Prestons Waste Treatment Facility

Amendment Report

Figure 1-1 Facility conceptual site layout

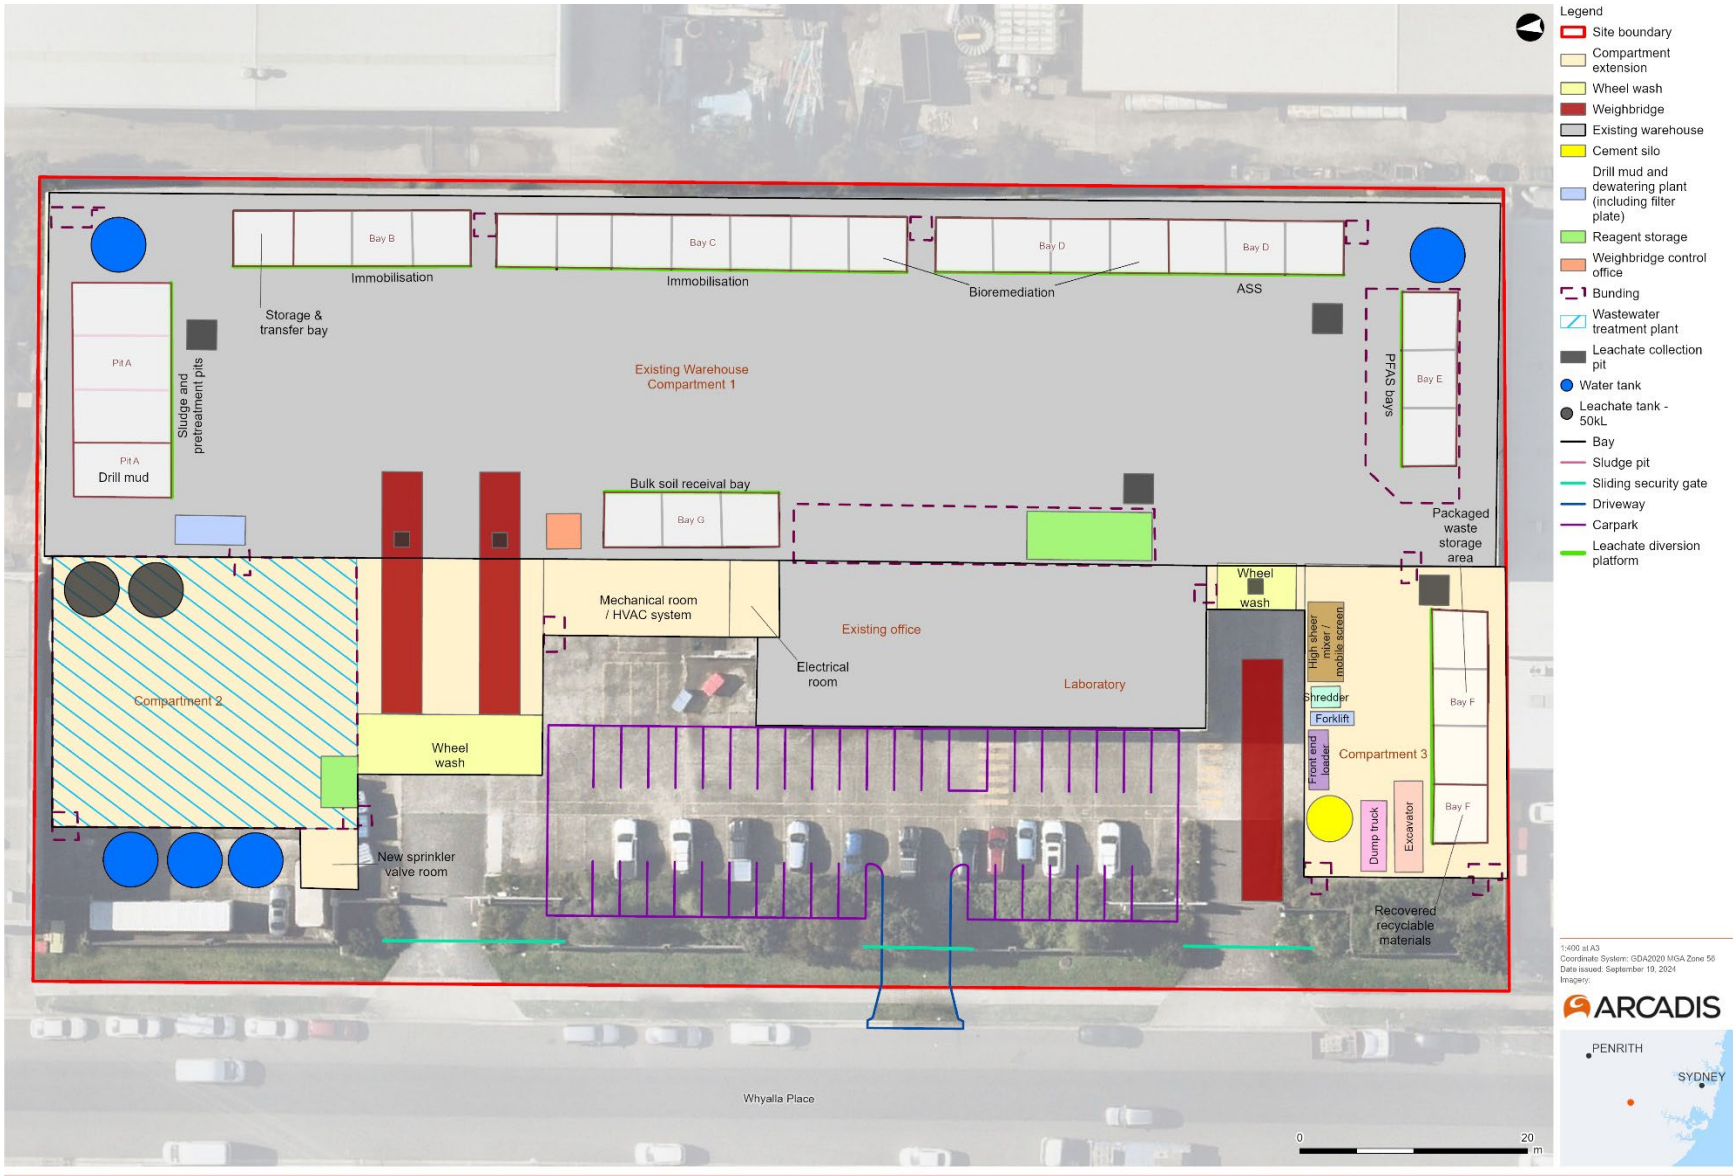
<p>4/12/2023 The figures in the ADR showing the floor plan of the facility are not adequate for the Department and EPA to understand how the area has been separated and controlled to prevent cross contamination.</p>	<p>Updated plans have been prepared by SMEC (Appendix E). The soil PFAS bays are located at the Southern end of Compartment 1.</p> <p>The PFAS storage bays are bunded and would not be interchangeable with the other treatment bays, which limits the potential for cross contamination. The Facility layout figure (Figure 1-3 of the Amended Proposal Description) shows the separation of treatment bays, bunding and leachate diversion platforms which would control cross contamination.</p> <p>The procedure for PFAS contaminated soil storage and the related environmental controls are provided in Section 6.2.3 of the OWMP (Appendix H). Once the material is removed from the Facility the used bay(s) will undergo decontamination with Decon 90, as described in the PFAS storage procedure in Section 6.2.3 of the OWMP.</p> <p>A Hazard Identification Report (Appendix L) has been prepared by Sherpa Consulting (2024) which considered risks from storage of PFAS soil and associated offsite safety and environmental risks; finding the proposed controls and management measures in place to be adequate to manage risk. No High risks were identified.</p>	<p>Figure 1-3 of the Amended Proposal Description (Appendix B)</p> <p>Consolidated Design Drawings (Appendix E)</p> <p>Section 6.2.3 of the draft OWMP (Appendix H)</p> <p>Hazard Identification Report (Appendix L)</p>

A dedicated, separated and controlled area would be provided within the facility to prevent cross contamination of PFAS contaminated soils with other materials stored and treated at the facility. This area is identified on Figure 1-1. All PFAS material would be temporarily stored onsite then transported to either Hi-Quality's Yatala facility for treatment and disposal or an appropriately licensed landfill. It is noted that Hi-Quality's Yatala facility is one of only two facilities on the east coast of Australia that are licensed to receive and treat PFAS material.

Figure 5-1: Conceptual site bunding and leachate treatment infrastructure

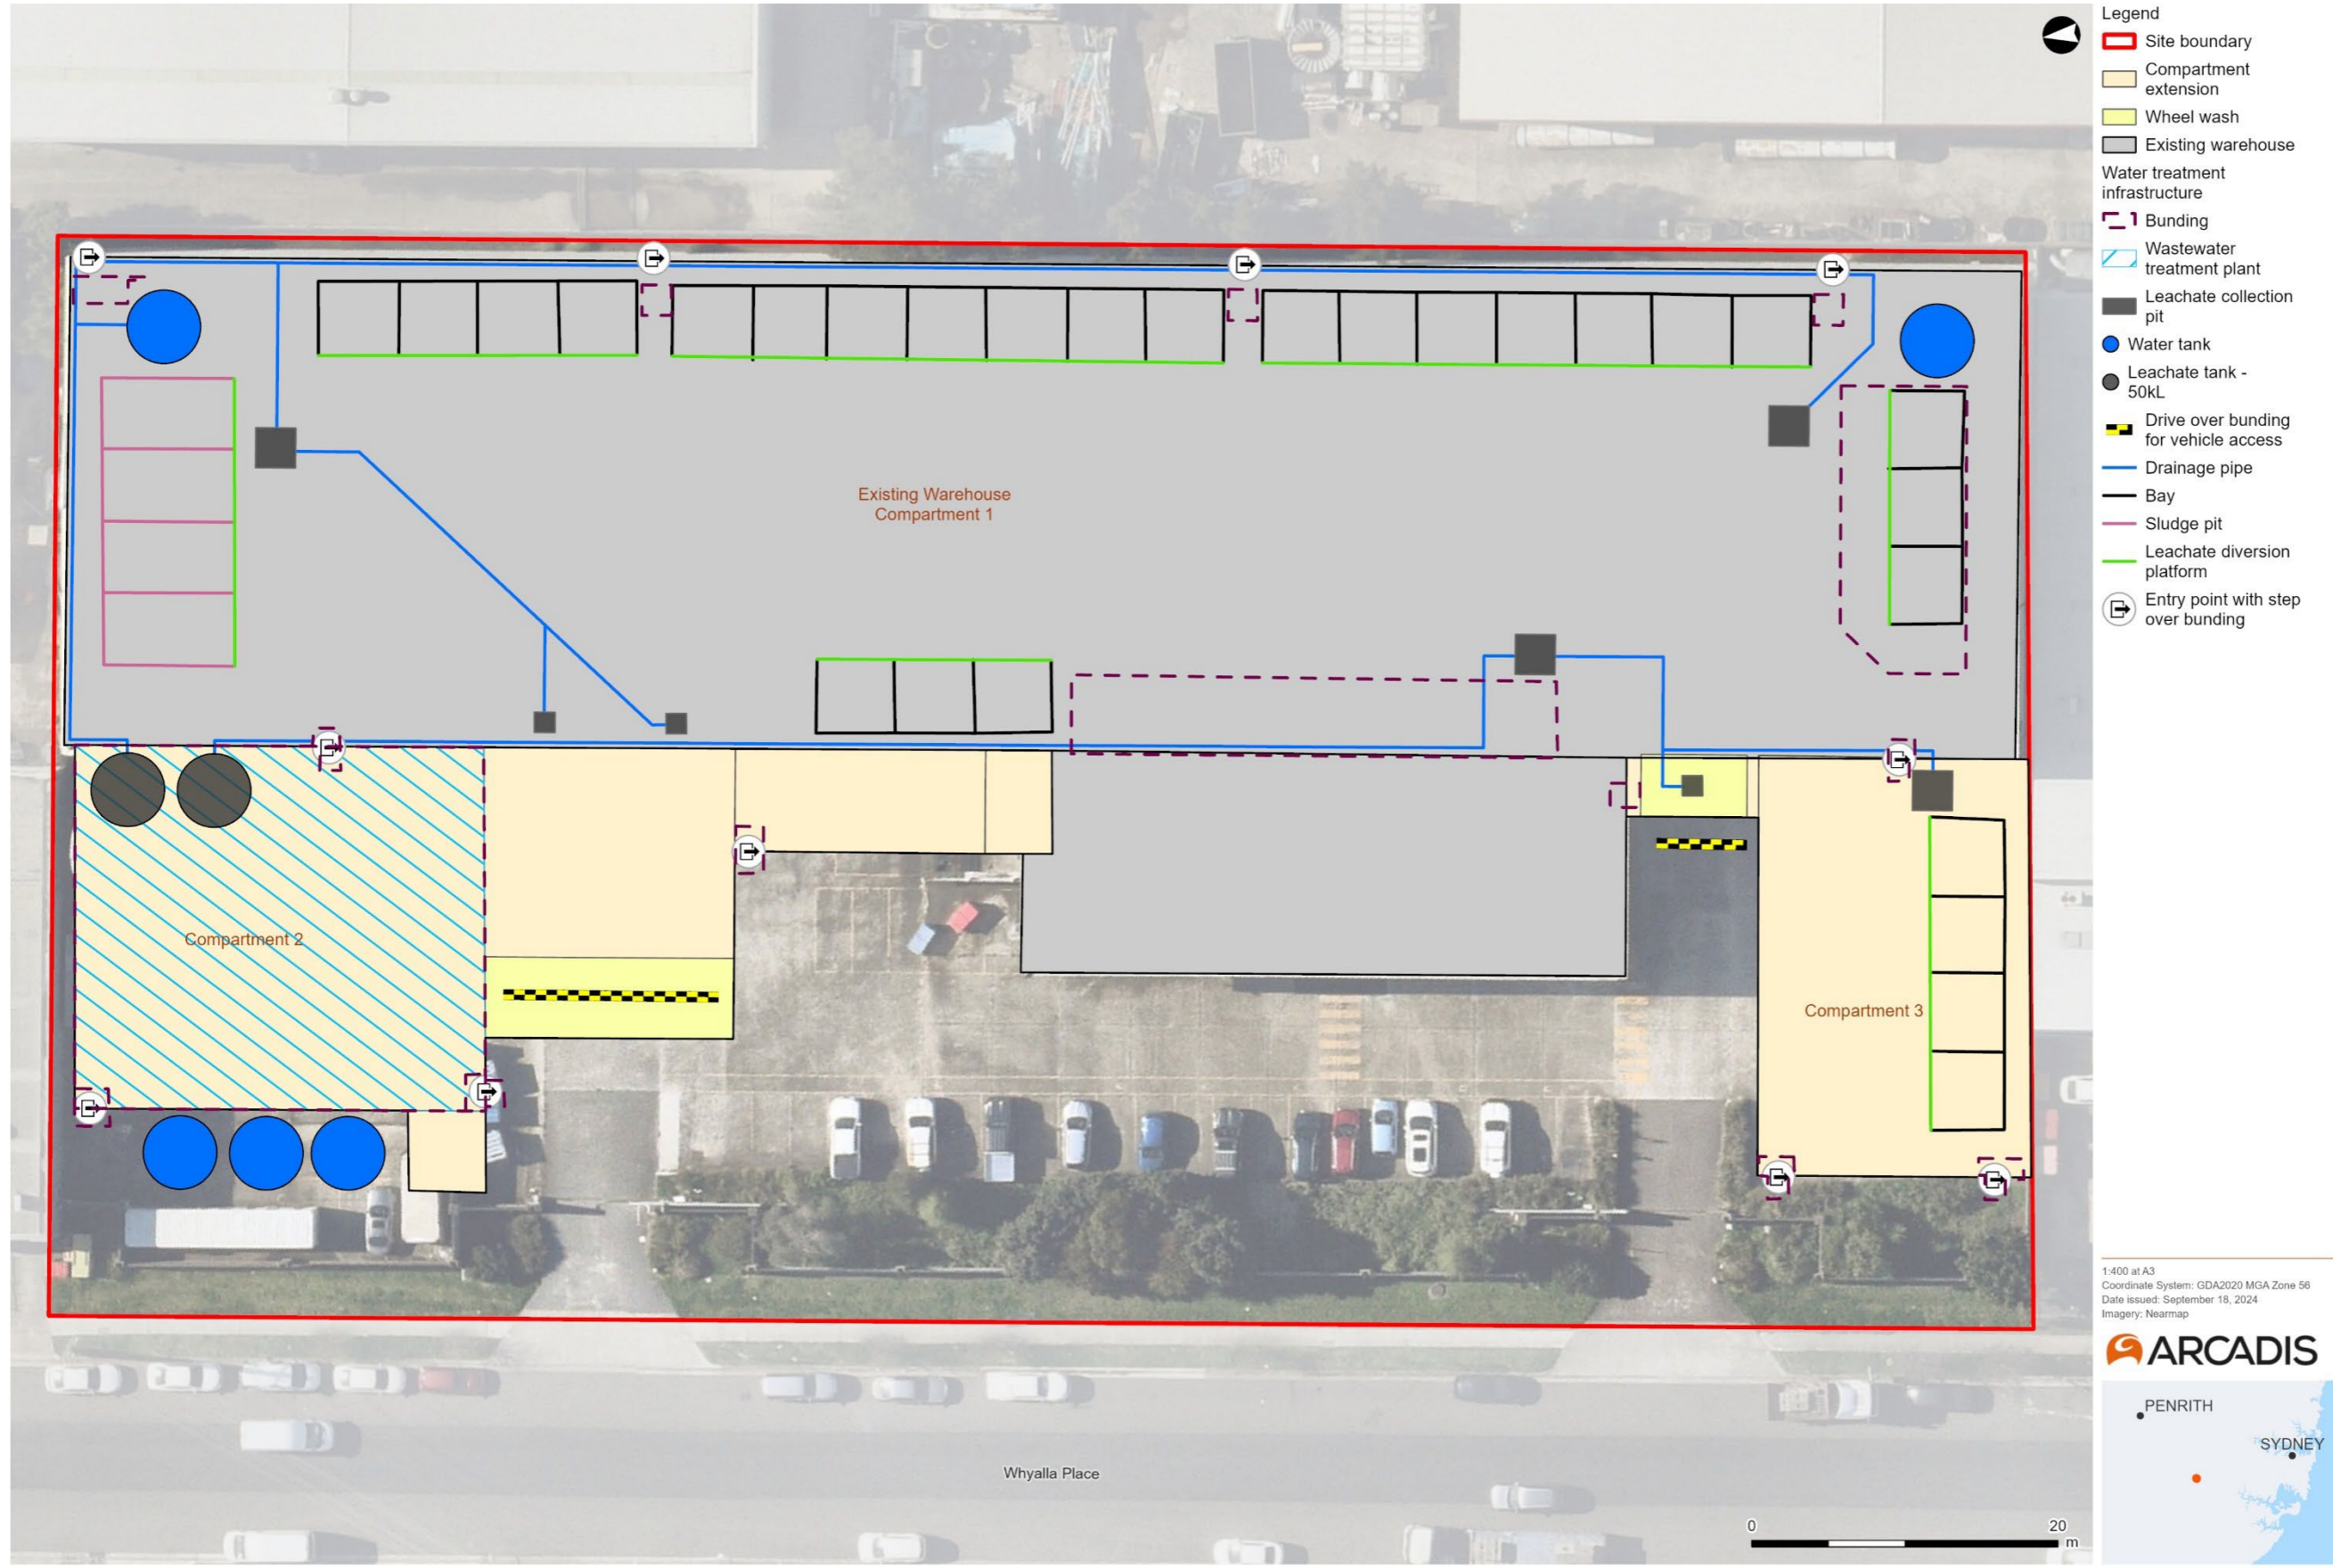
EPA Query (including date of query)	Response/Comment	Reference
Water and leachate management infrastructure		
<p>4/12/2023 The Department and the EPA have previously requested detailed plans for the proposed leachate and water management systems. The ADR at Figure 3.3 provides only a basic concept for the water and leachate management infrastructure which is laid over top of an aerial of the roof of the building. Although Section 3.3 of the ADR describes the proposed system, the applicant has not provided detailed plans to show that this system can work on site and what modifications to the existing hardstand areas and building are required to facilitate the system (creating necessary fall etc.). A detailed leachate and water management plan is required.</p> <p>4/12/2023 Section 1.2.8 of Appendix B suggests the leachate collection pits would be excavated into the ground and would involve ground-breaking internal to the warehouse building. What depth are the pits proposed to be provided at? What flood level would these pits be installed at?</p>	<p>An updated and consolidated set of plans have been prepared by SMEC for the proposed Facility and are provided in Appendix E of this Amendment Report.</p> <p>Drawing CC-201 shows where changes to existing hardstand would be required to install leachate management infrastructure. Cross Sections for Compartment 1 are provided in E5 Structural Design. Design Drawings E4 shows the design for the Hydraulics Services that would be installed as part of the Facility.</p> <p>Section 1.2.9 of the Amended Proposal Description (Appendix B) outlines the proposed leachate management system that would be installed at the Facility and includes a summary figure of the key leachate infrastructure features.</p> <p>Section 2.4.2 of the OEMP outlines how water and leachate will be managed.</p> <p>The Revised Environmental Management Measures (Appendix C) have been updated, such that G2 includes a commitment to prepare an Operational Stormwater and Leachate Management Plan.</p>	<p>Consolidated design drawings (Appendix E)</p> <p>Section 1.2.9 of the Amended Proposal Description (Appendix B)</p> <p>Section 2.4.2 of the draft OEMP (Appendix F)</p> <p>Revised Environmental Management Measures (Appendix C)</p>

- The PFAS bays would be bunded with urethane bunding, as shown in Figure 5-1, any leachate generated in the PFAS storage bays would be pumped using portable pumps into containers for disposal.

- Bund provided = 250 mm (sufficiently greater than the minimum)

Figure 5-2: Estimated carparking demand onsite

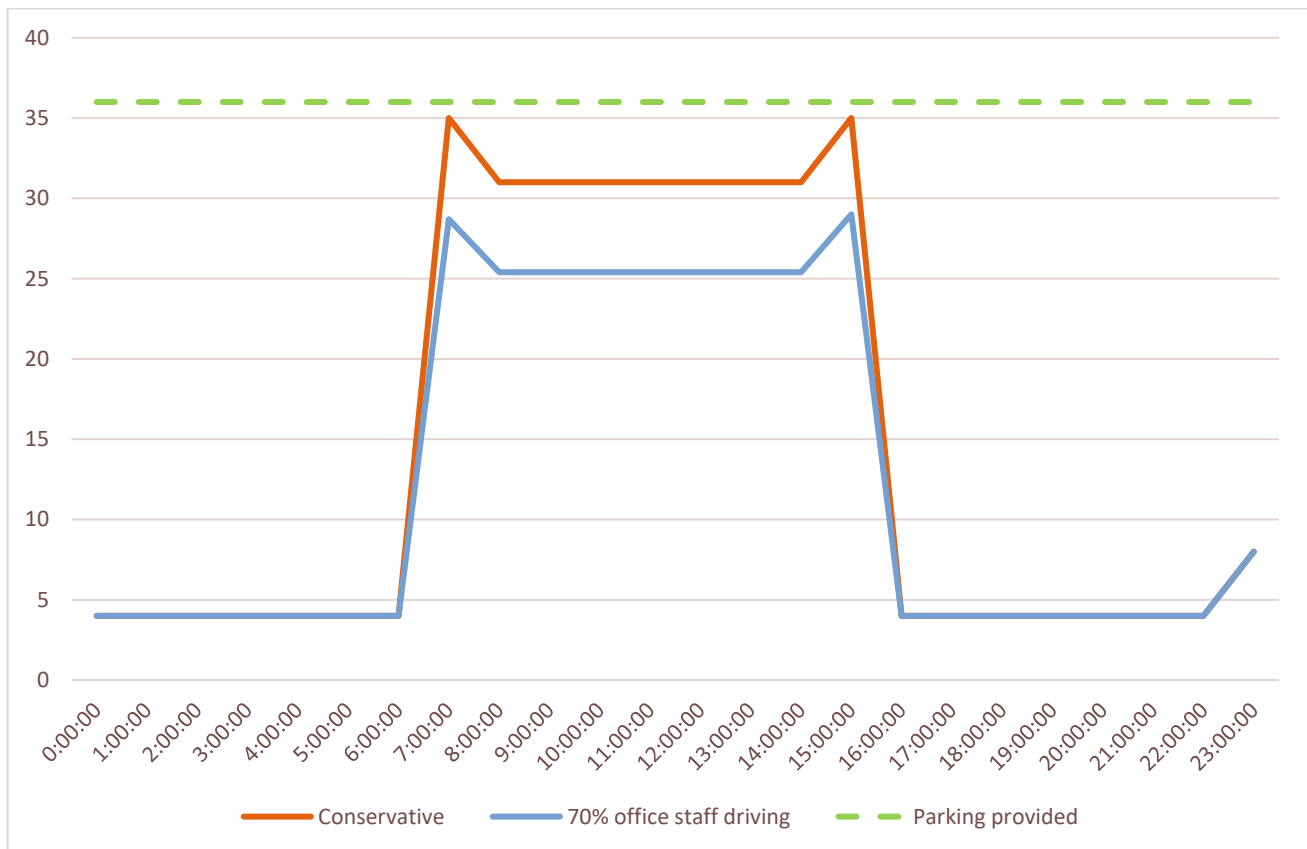
Parking and swept path diagrams	Parking provision and swept path diagrams are to be provided to Council's satisfaction.	Hi-Quality has prepared a draft Operational Traffic Management Plan (OTMP) which is provided in Appendix I. This includes updated swept path diagrams and displays the parking provisions. The final OTMP, to be prepared following project approval, can be provided for Council review as required.

A graph for how car parking could potentially operate on a typical day where all staff are onsite between 7:00AM and 3:00PM is provided in Figure 5-2. The orange line shows the car parking demand, should all office workers choose to use their cars while the blue line shows a scenario where 70 per cent of office workers use their car and 30 per cent use alternative transport. It has been assumed that 100 per cent of staff working within the Facility would drive their own car to work for both the blue and orange scenarios. As noted in the Stanbury Traffic Planning Report (Appendix E of the RtS Report), it is likely that on any given day, that there would be a proportion of staff that would car pool, catch public transport, work from home, visit Hi-Quality sites, be at meetings in other locations, not commence work in the office at 7:00AM or finish work in the office earlier than 3:00PM for that particular day.
